Job Name:	Queensbridge Farm, Overton-on-Dee
Job No:	332613092
Note No:	003
Date:	July 2026
Prepared By:	Harry Keech: Assistant Transport Planner
Approved By:	Brian Laird: Technical Director – Transport Planning
Subject:	**Proposal: Change of Use of Land to Create Glamping Site** **Land South of Queensbridge Farm, Overton, Wrexham, LL13 0LE** **Planning Application Reference: P/2025/0854**

2.3. This Technical Note (003) has been produced to address Wrexham Council's 9 July 2026 Memorandum response.

SWEPT PATH ANALYSIS: REFUSE VEHICLE AND ESTATE CAR

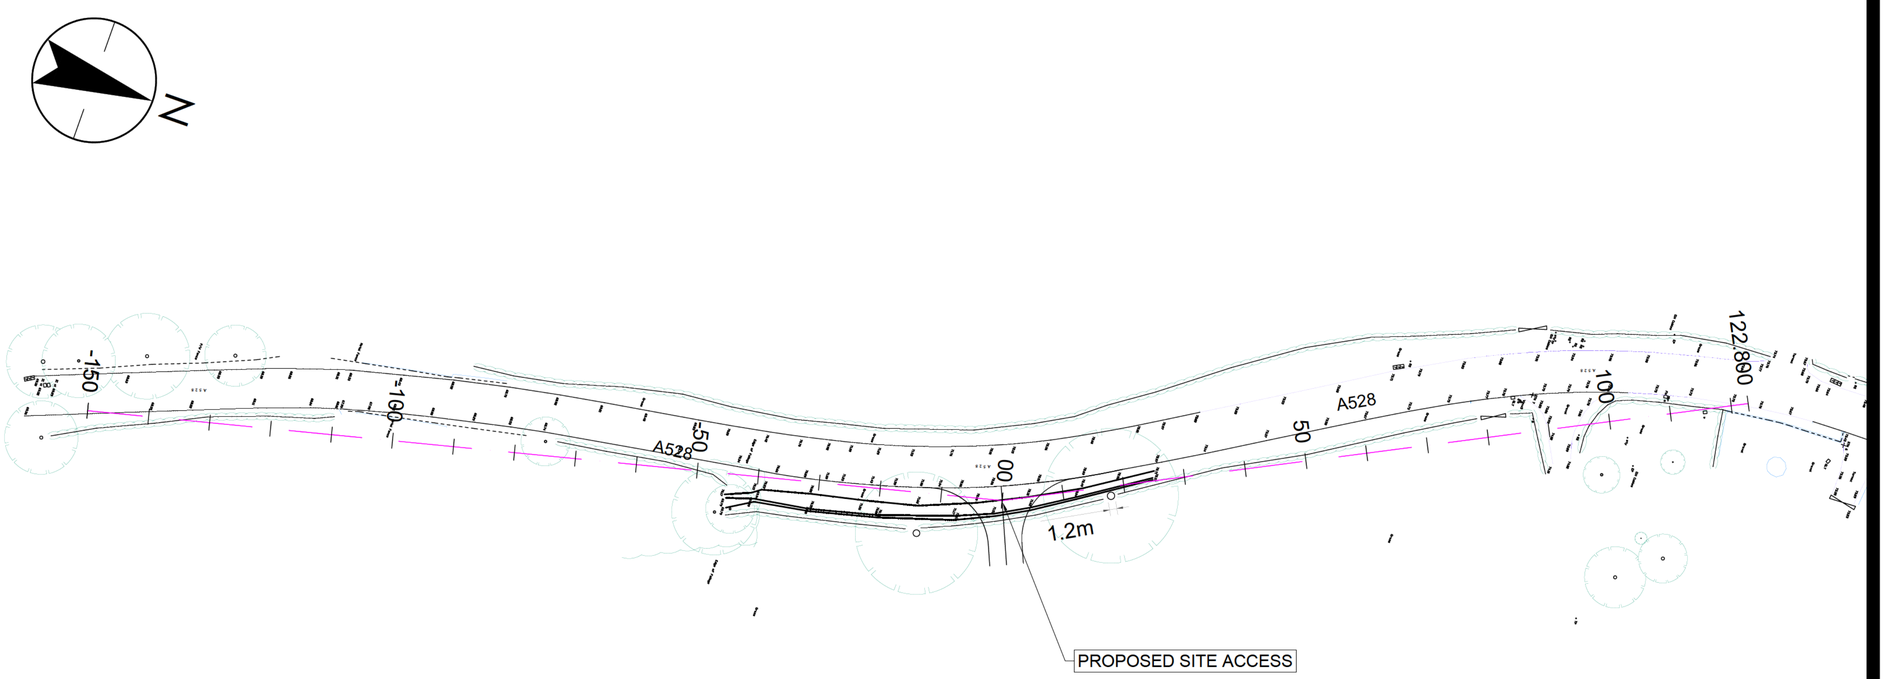
7.6. Although it was stated in TN002 that waste collection will be carried out by private waste collector, for robustness and to address the comments raised by Wrexham Council, swept path analysis has been updated for a 11.347m long large refuse vehicle and a 5m long car. It should be noted that a refuse vehicle will visit the site only once a week and the chances of a refuse vehicle entering / exiting at the same time a 5m long car entering / exiting the site will be a rare occurrence.

7.7. As requested however, **Drawing 332613092/100/007 P04** shows a 11.347m long large refuse vehicle turning left into the site at the same time as a 5m long car turning left out of the site. In addition, the drawing shows a 5m long car turning left into the site at the same time as a 11.347m long large refuse vehicle turning left out of the site.

7.8. The drawing also shows the centre line of the A528, which demonstrates that the vehicles do not encroach into any part of the oncoming lane when turning left into or out of the site.

Title
SITE ACCESS VISIBILITY SPLAY

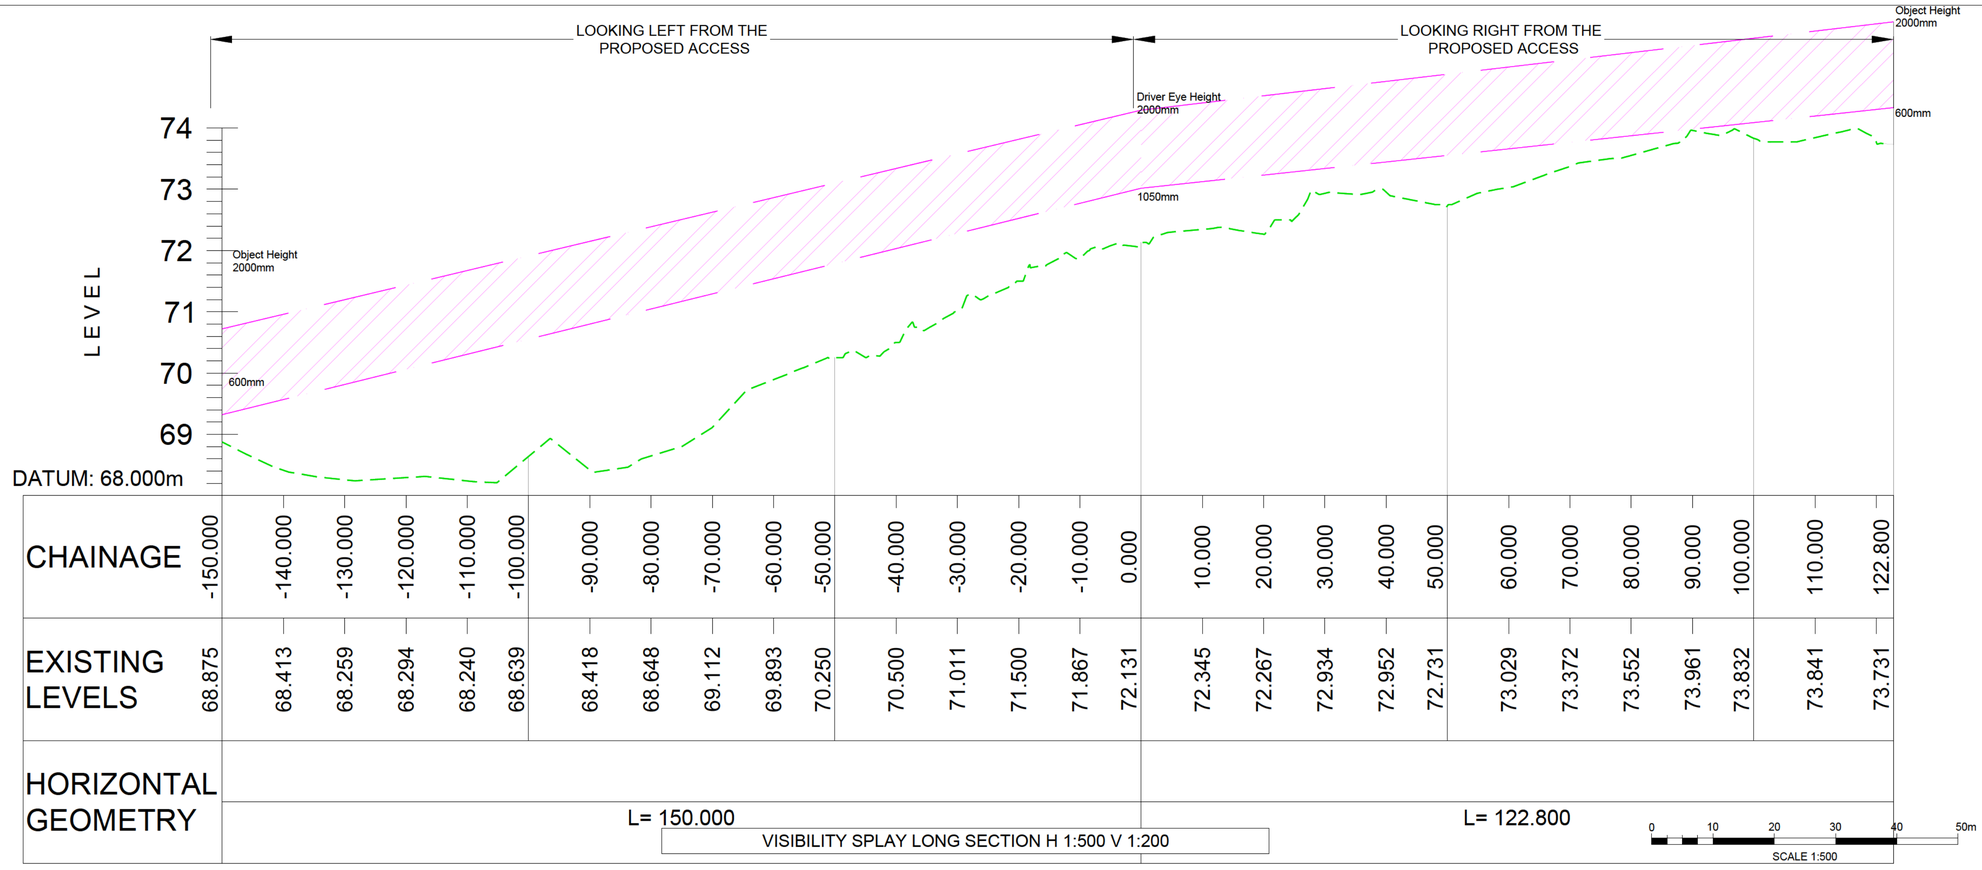
4.1. Regarding the tree located to the north of the proposed site access, Wexham Council has stated "*The existing tree trunk diameter of the mature tree in this location is of a significant size and needs to be plotted / drawn accurately as it may well limit the available visibility in the northerly direction*."

5.1. Regarding the existing private shared driveway, Wrexham Council has stated "A*ny splays cutting across the existing private shared driveway or any physical modifications to the existing private road itself (as would appear to be the case) would require a suitable legal agreement (eg/ s.106 agreement) including all property owners served off the private driveway. This requirement has been confirmed by the WCBC Planning Department. If such an agreement cannot be achieved, then the achievable splay in the northerly direction will be significantly reduced again*."

5.2. Wrexham Council has also stated "*The submitted site location plan does not appear to provide evidence of ownership by the applicant of the private shared access road serving the six properties over which the proposed / required splay in the northerly direction would cut cross. It is therefore assumed that the required splay cannot be delivered over land under the applicant's control."*

4.2. Stantec confirms that the proposed site access drawings are based on a topographical survey that has accurately plotted the location of the tree. From the drawing, the trunk of the tree is measured at 1.2m. In addition, the Applicant has taken a measurement of the tree and has confirmed that it measured 1m in diameter.

4.3. In conclusion, the location of the tree and diameter of the tree, as shown on the drawing can be considered as accurate. It is clear from the drawing, that the tree trunk is behind the visibility splay and therefore will not obstruct the visibility splay.

5.3. The proposed site access drawing shows a long section of the visibility splay to the north and south of the site, showing visibility in the vertical plane. It can be clearly seen from the drawing that a driver sitting at the site access, waiting to turn onto the A528 would be able to see from a height of 2 m high down to a point 600 mm above the carriageway in both directions, as referred to in paragraph 7.6.3 of Manual for Streets. It should be noted that TAN 18: Transport makes no reference of driver height and provides no guidance to what document that driver height should be taken from.

6.2. **Drawing 33261309/100/005 P03** shows a visibility splay of 2.4m x 150m to the south, which is in accordance with Wrexham Council's requirements.

6.3. To the north, the maximum visibility splay achievable due to the vertical alignment of the A528 is 2.4m x 122.8m. Wrexham Council has requested a visibility splay of 2.4m x 139m, whilst this is not achievable, the achievable visibility to the north is only 16.2m short, which is approximately only three car lengths.

8.1. In conclusion, the proposed site access, providing a visibility splay of 2.4m x 150m to the south and 2.4m x 122.8m to the north, should be considered acceptable when taking account of the additional benefits that would be delivered to existing residents of Queensbridge Lane.
